THE MARYLAND-NATIONAL CAPITAL PARK AND PLANNING COMMISSION
Office of the Chairman, Montgomery County Planning Board

DATE: May 10, 2002
TO: Montgomery County Planning Board
FROM: A. Malcolm Shaneman
Development Review Division
(301) 495-4587
SUBJECT: Informational Maps for Subdivision Items on the
Planning Board's Agenda for May 16, 2002.

SUBJECT: Fairland Gardens, Parcel 316, Preliminary Plan No. 1-01068 and SPA Combined Preliminary and Final Water Quality Plan

Re: **Preliminary/Final Water Quality Plan for**
Fairland Gardens, Parcel 316
Preliminary Plan #: 1-01068
SM File #: 203984
Tract Size/Zone: 0.92 Ac/RE-1
Tax Plate: KR-343
Liber/Folio: 5559/772
Montg. Co. Grid: 32B4
Watershed: Upper Paint Branch

NRI/FSI PLAN

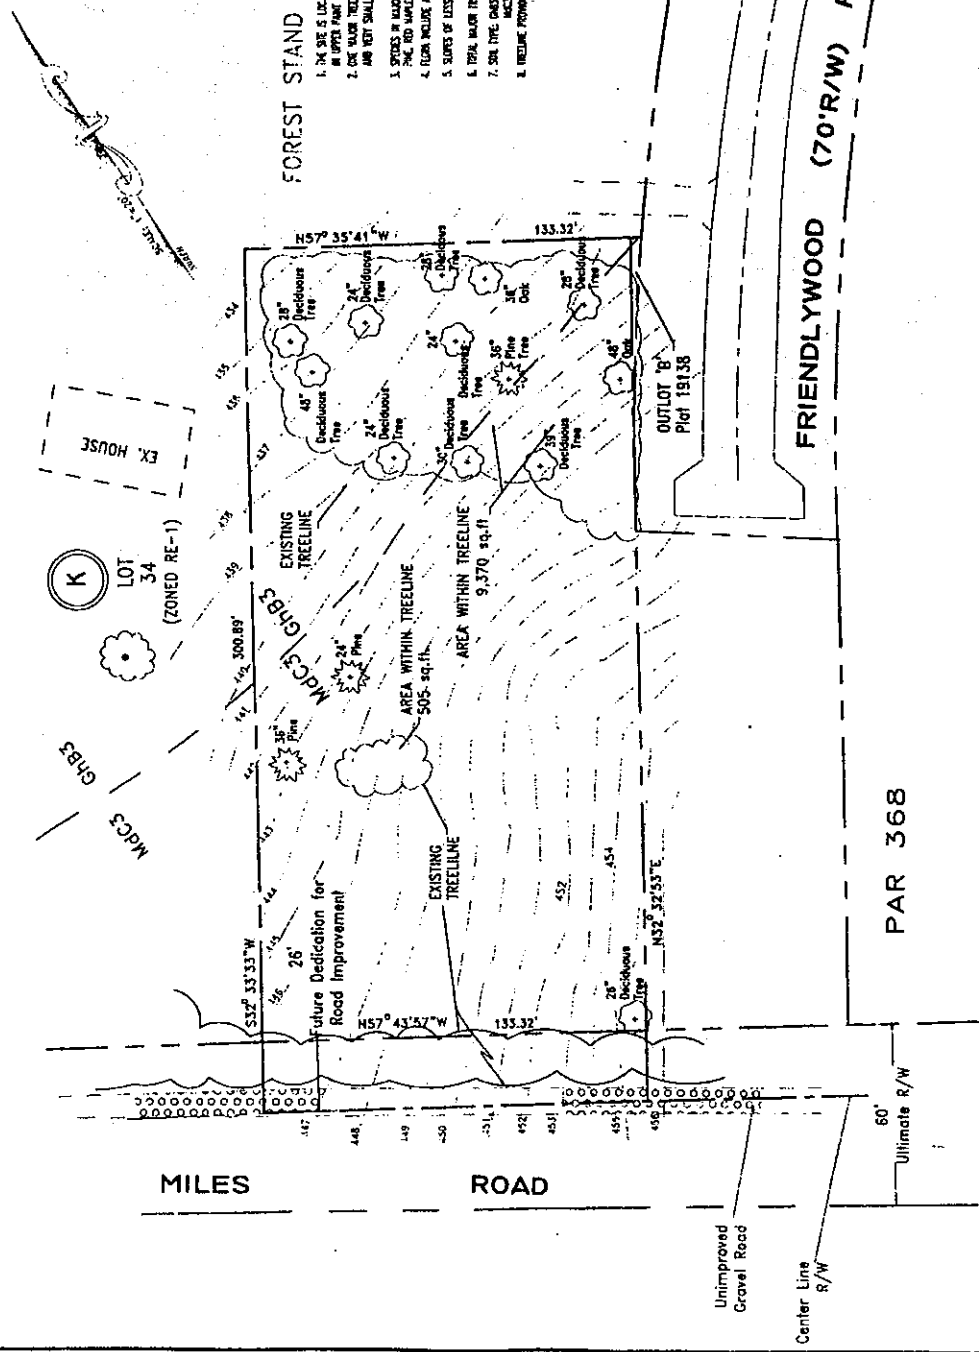
The 0.92-acre property lies in the Upper Paint Branch Special Protection Area (SPA). The property is entirely on uplands. There are no streams, wetlands, or environmental buffers on

the property. One single-family detached lot is proposed. There is a small stand of forest and some scattered trees on the site.

An environmental overlay zone exists in the Upper Paint Branch SPA. The overlay zone restricts impervious cover in new development to no more than ten percent (10%). The water quality plan proposes 0.09 acre (3985 square feet) of impervious surfaces. This includes about 3000 square feet for the house and garage, 985 square feet for the driveway.

There is a small forest stand (about 10,000 s.f.) on the northern portion of the site. There are no specimen or champion trees. The proposed limits of disturbance are immediately adjacent to one edge of the forest. However, staff estimates that about 2800 s.f. of the forest edge will be removed or negatively affected to construct the garage. Since the site is less than one acre, less than 30,000 s.f. of forest will be cleared, and no specimen or champion trees will be cleared, the proposed subdivision is exempt from requirements of the Forest Conservation Law. However, staff recommends that prior to construction, the M-NCPPC inspector meet with the land owner and construction contractor to establish the exact limits of the forest save area and appropriate tree protection measures.

1. Prior to record plat, applicant to enter into an agreement with the Planning Board to limit impervious surfaces to no more than 10 percent as shown on the revised preliminary plan.
2. Prior to release of building permits, applicant to demonstrate conformance to impervious surface limits as shown on the revised preliminary plan. Any modifications to these plans which increase site imperviousness may require Planning Board action.
3. Conformance to the conditions as stated in DPS' water quality plan approval letter dated October 22, 2001 (Attachment 1).
4. Conformance with the limits of disturbance as shown on the revised "Water Quality Treatment Plan". Specific boundary of tree-save area and any tree protection measures to be determined by the M-NCPPC inspector in conjunction with the land owner and construction contractor prior to the start of construction.
